APPLICATION NO.	FILING DATE	FIRST NAMED INVENTOR	ATTORNEY DOCKET NO.	CONFIRMATION NO.
10/697,379	10/30/2003	Alex D. Vandertol	026032-4321	7895

Office Action Summary

This is the first office action for application number 10/697,379, System and Method for Mounting In-Vehicle Electronics, filed on October 30, 2003.

Patent number 5,850,078 to Giordano et al.

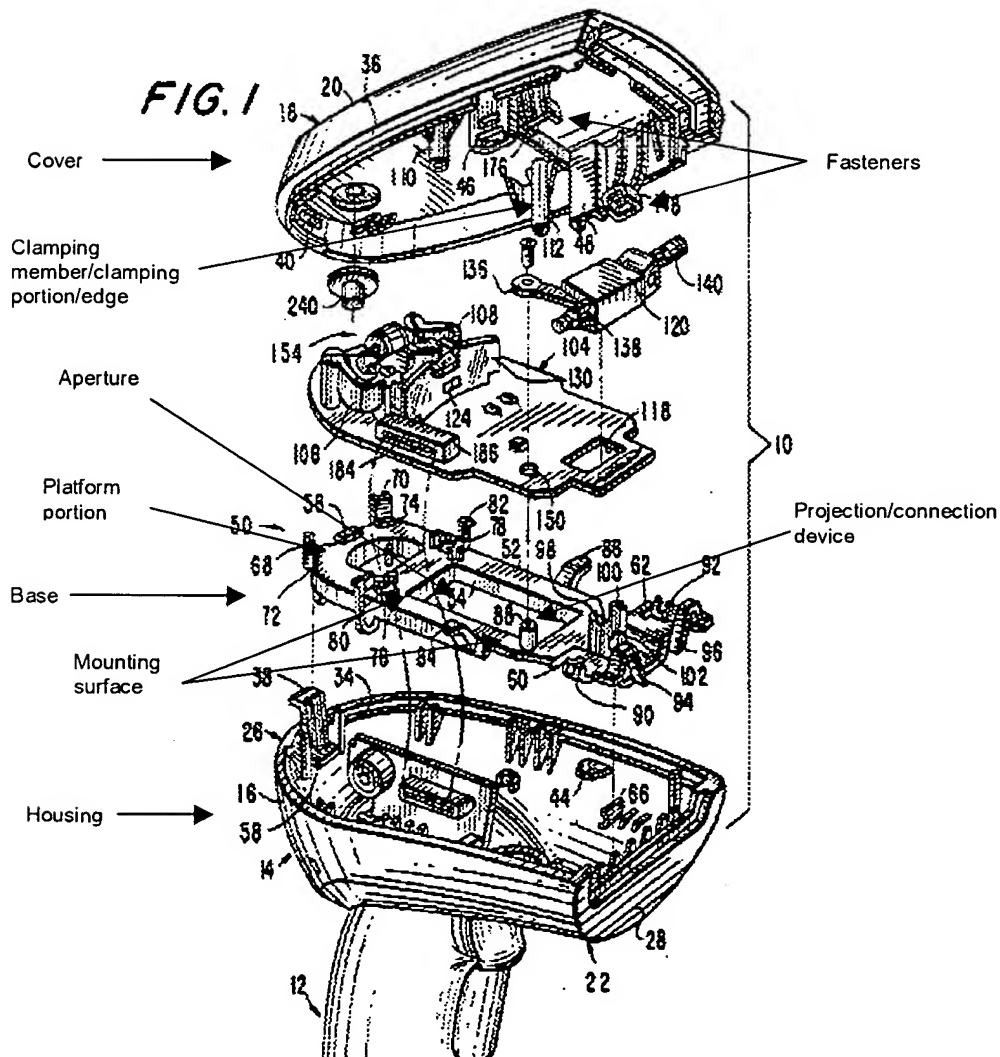
Claims 1-8 and 15-25 are rejected under 35 U.S.C. 102(b) as being anticipated by U.S.

Giordano et al. '078 discloses a mounting structure/system (above) comprising a base (above) with an aperture (above) therein, a cover (above) coupled to the base, wherein the base includes a platform portion (above, top of base, generally) having at least one mounting surface (above) formed thereon adjacent the aperture and at least partially surrounding the aperture, wherein the cover further comprises a clamping member/portion comprising an edge of the cover (above, it inherently could act as a clamping member), wherein the cover is coupled to the base by fasteners (above), wherein the mounting surface could inherently position a device at an angle relative to the base (inherently *some* angle), wherein the mounting surface includes a projection (above), wherein the cover further comprises at least one connection device for coupling the cover and the base member, wherein the system includes a housing (above) having a first attachment structure (58) for coupling to the base member and a second attachment structure (12), wherein the mounting structure could inherently perform all claimed functions and be used with all objects/members functionally recited throughout the claims.
